FILE NO.: HR 17-05 - Alterations to the roofline of a locally designated Landmark located within the Canemah National Historic District.

REQUEST: Alterations to a locally designated landmark located within the Canemah Historic District to extend the roof eaves and add a covered porch.

REVIEWER: Trevor Martin, Planner

RECOMMENDATION: Approval with Conditions

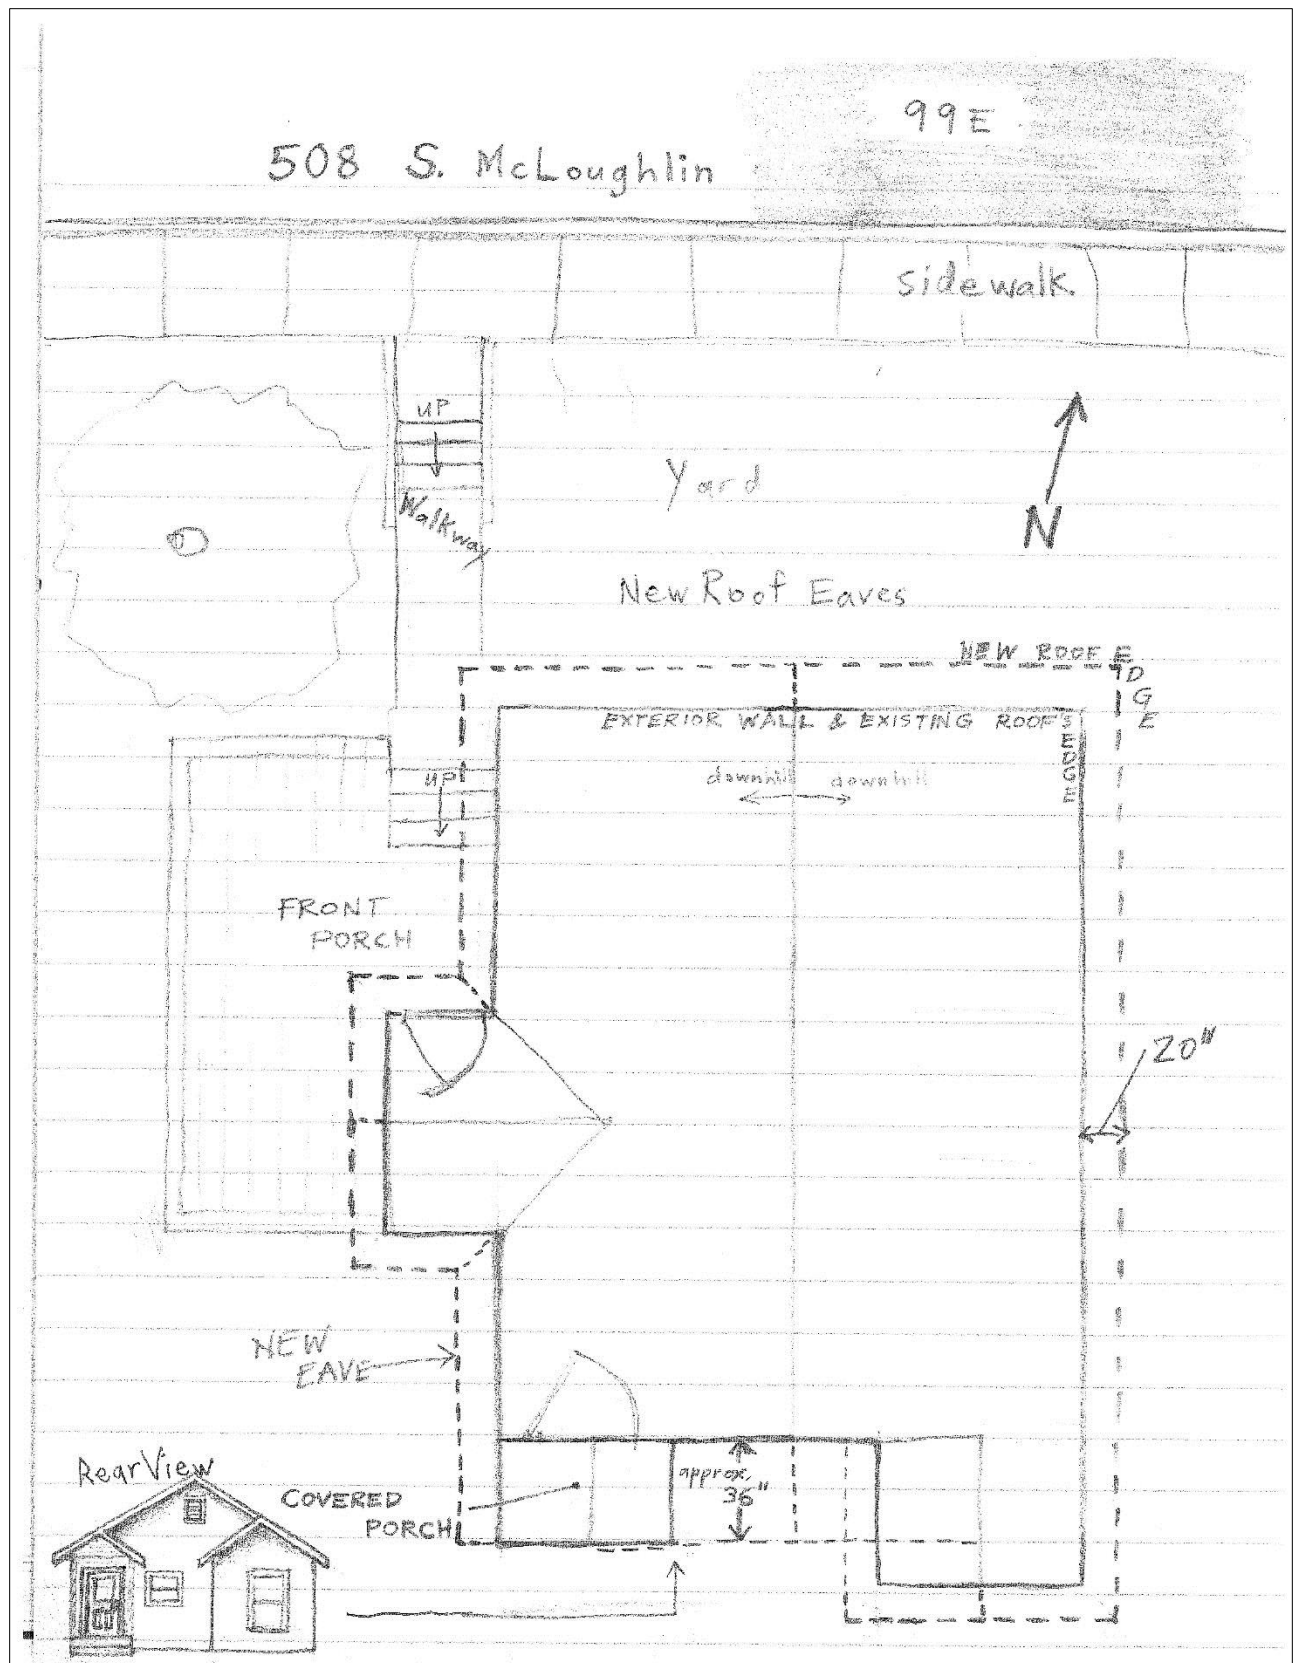
1. The roof shall have a minimum 1 foot overhang with a maximum of 3 feet; where soffitted the enclosure is typically parallel to the rafters.
2. Prior to issuance of a Building Permit, staff shall ensure that:
 - a. Incised lumber or pressure treated wood shall not be used on any visible surfaces. (P)
 - b. Trim shall be finished to match all railings, decking and stairs of the house.(P)
 - c. The applicant shall utilize the following:
 - i. Gable trim consisting of a simple bargeboard with molding at roofline and a wide molded rake board.(P)
